Staff Report
Board of Architectural Review for Woodspring Suites
Prepared April 21, 2016

FILE NUMBERS: L15-0042 Design Review
L15-0043 Shoreline Substantial Development

REQUEST: Board of Architectural Review approval for development of a four-story, 110-room Woodspring Suites extended stay hotel located on the west side of West Valley Highway south of I-405. A garage and stable located on the project site and extending on to the parcel to the east are proposed to be demolished. The project site is located between the Green River and the historic Nelsen Residence.

Figure 4. Landscape Perimeter Averaging

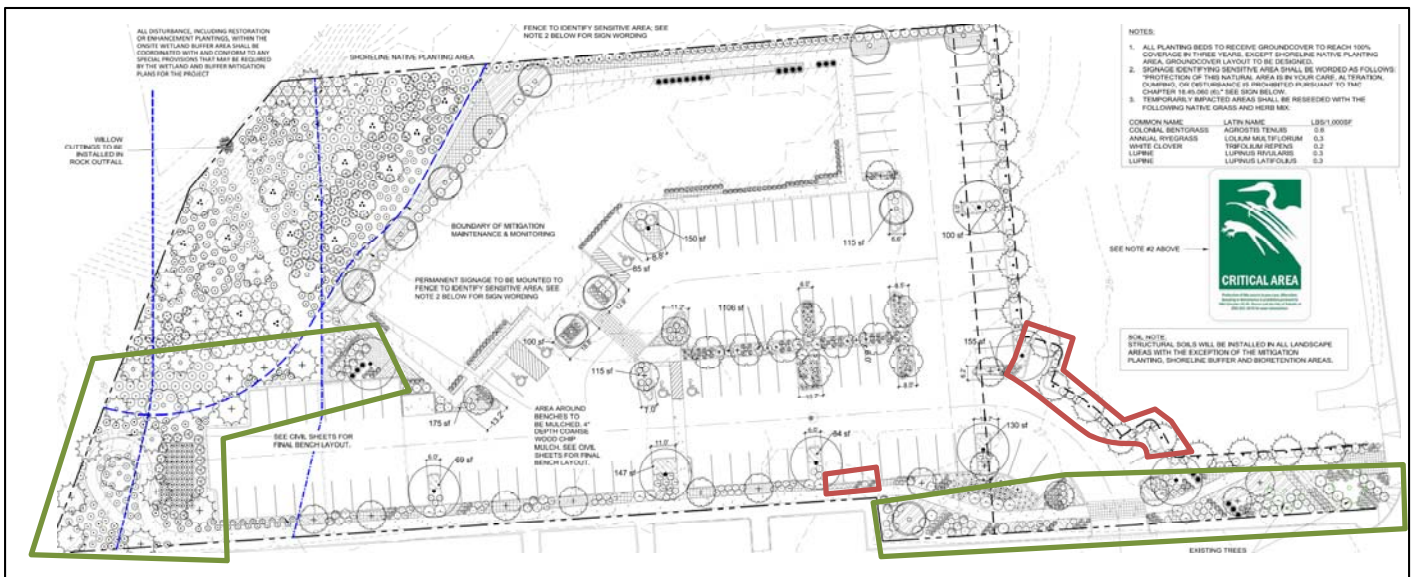
The project meets the minimum setback requirements for the side and rear yards. Per the District Standards contained in Table 18-3, side and rear yard setbacks and landscaping requirements may be waived as part of design review in the TUC-TOD District if Building and Fire Code requirements are met. Along the south property line in the area west of the entrance driveway for the Woodspring Suites, a sidewalk is proposed within the five-foot side yard landscape area. A five-foot planting strip located in between the sidewalk and the Woodspring Suites parking lot serves the function of perimeter landscaping in this area. In other areas of the site outlined in red in Figure 4e, the perimeter landscape does not meet the five-foot width for side yards.

The landscape design meets the criteria for approval of perimeter landscape averaging. Extra perimeter landscaping on either side of the Woodspring Suites’ entry drive and on the west side of the project site achieves the required square footage. Plant material is clustered in perimeter landscape areas adjacent to the Nelsen Residence to screen the parking area of the hotel from the Nelsen Residence. Structural soil in this area will also promote the health of plantings in this area. The planting areas outlined below in green also cluster plant material to screen parking areas. Perimeter averaging adjacent to the Nelsen Residence will allow the driveway to the Nelsen Residence to be preserved. Existing curb cuts will remain, and only one entry to the Woodspring Suites is proposed along the south property line. Reduction of the landscape width in the areas in red below does not diminish the ability for landscaping in these areas to be able to thrive, and does not diminish the quality of the site landscape as a whole.
